1982 Corvette: Service News: Fuel Filter Usage and Installation

Subject: Fuel Filter Usage and Installation

Source: Chevrolet Service News

Date: November/December 1982 - Volume 54-6 - Number 12

Fig. 1 — Fuel Filter

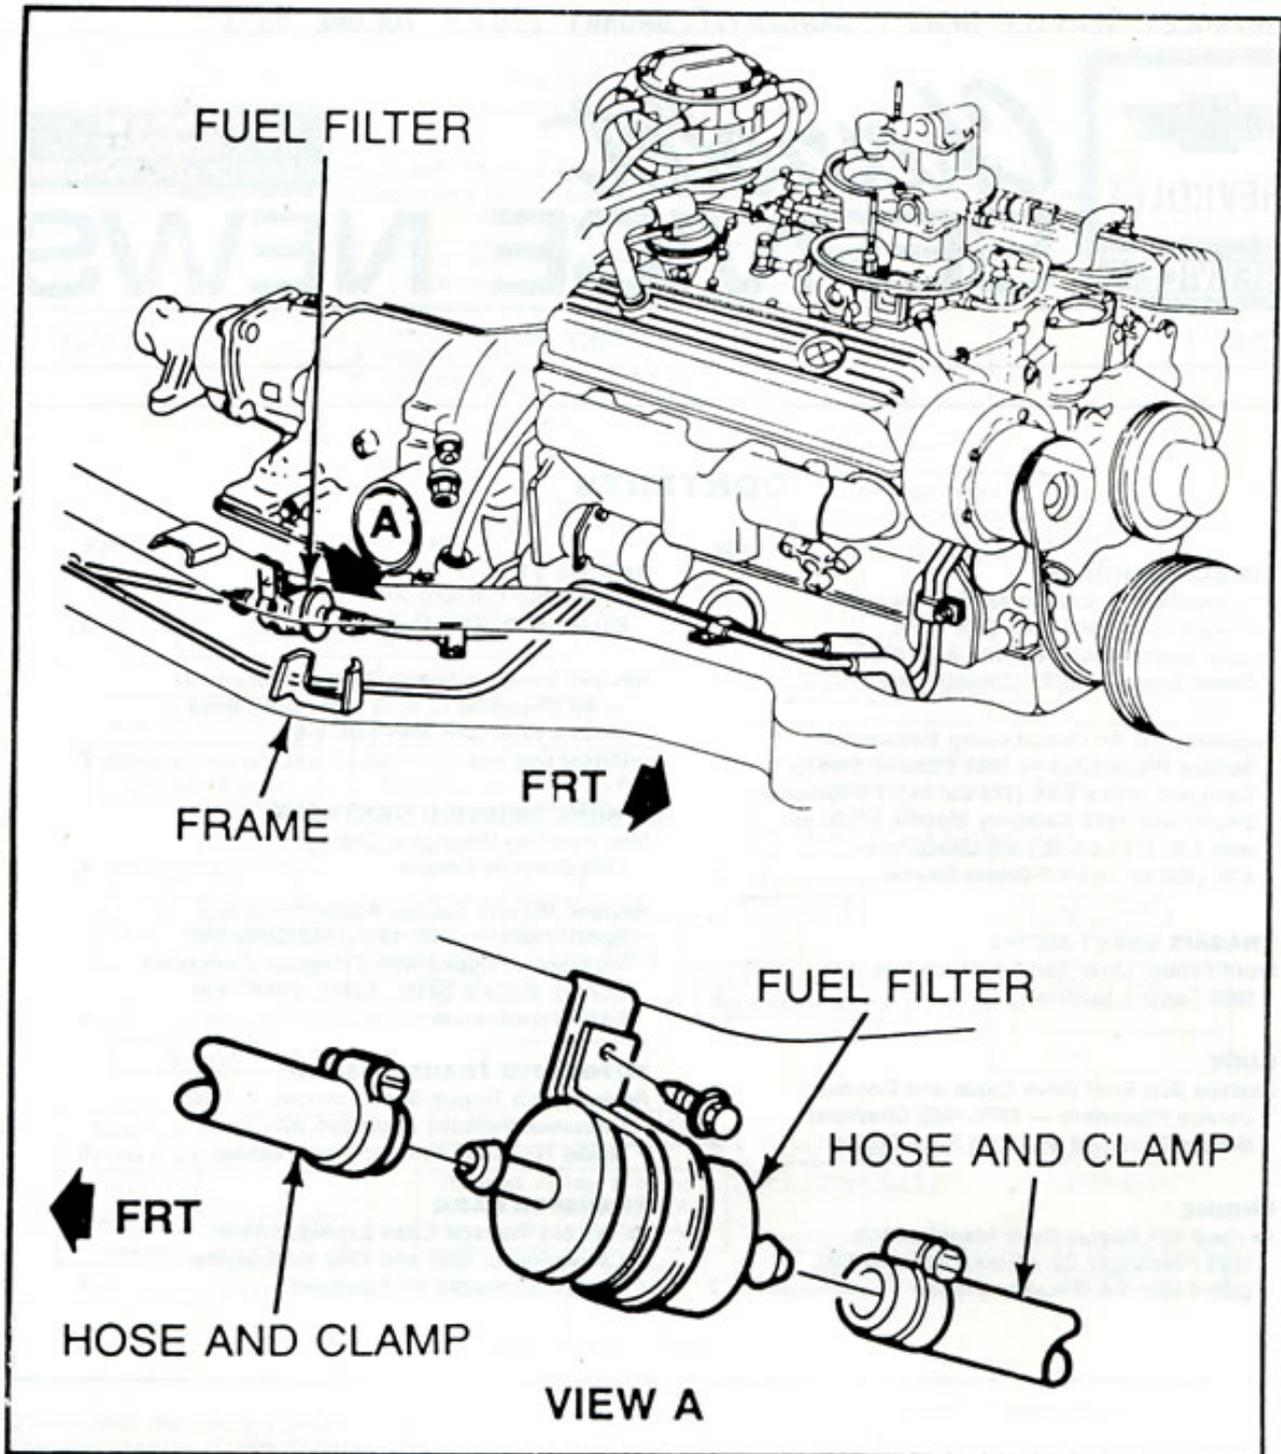
The fuel filter number, GF478, shown on Page 7-2 of the 1982 Corvette Owner's Manual and Figure 6C-3 shown in Section 6C of the 1982 Corvette Shop Manual (ST-364-82) are incorrect. The correct fuel filter number is GF482 and Figure 1 should be used in place of Figure 6C-3 shown in the Corvette Shop Manual.
